STATE OF HAWAII
DEPARTMENT OF TRANSPORTATION
HIGHWAYS DIVISION

ROADWAY DETAILS

KAHEKILI HIGHWAY WIDENING
Likelike Hwy. to Vicinity of Haiku Road
F.A. PROJECT NO. NH-083-1(26)

SECTION B
Scale: 3/4" = 1'-0" T7Q77C

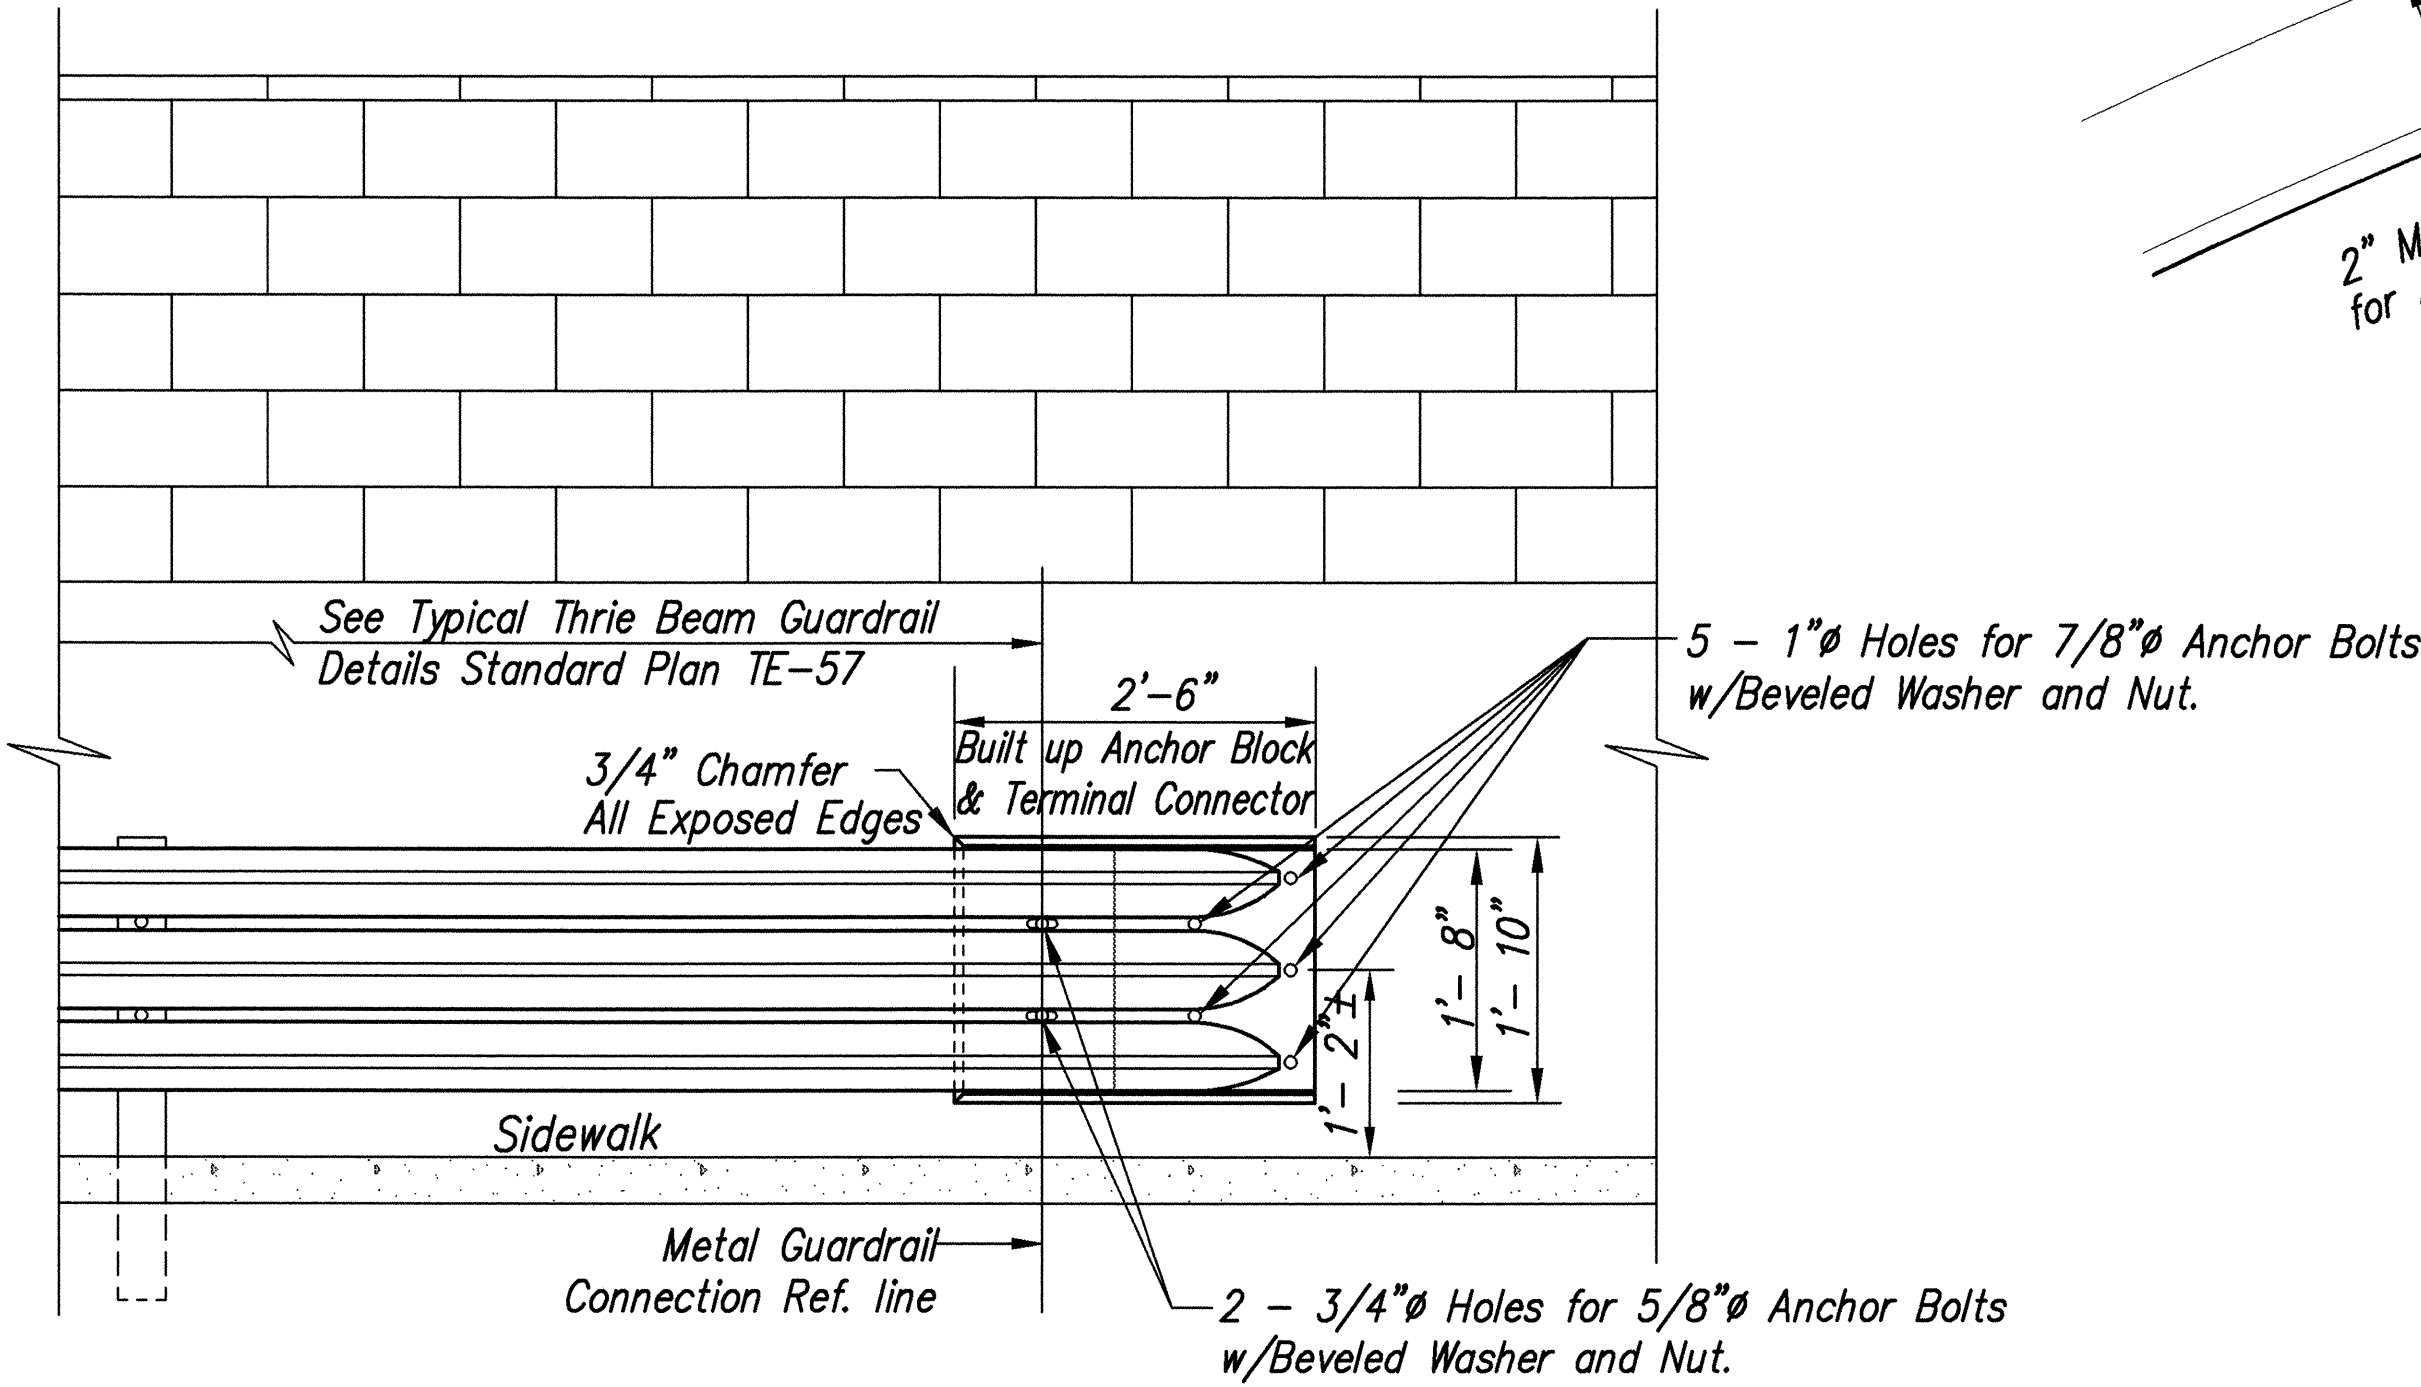
12/16/97	REPLACE SRT-350 WITH THRIE BEAM WITH WALL TERMINAL CONNECTOR.
DATE	REVISION
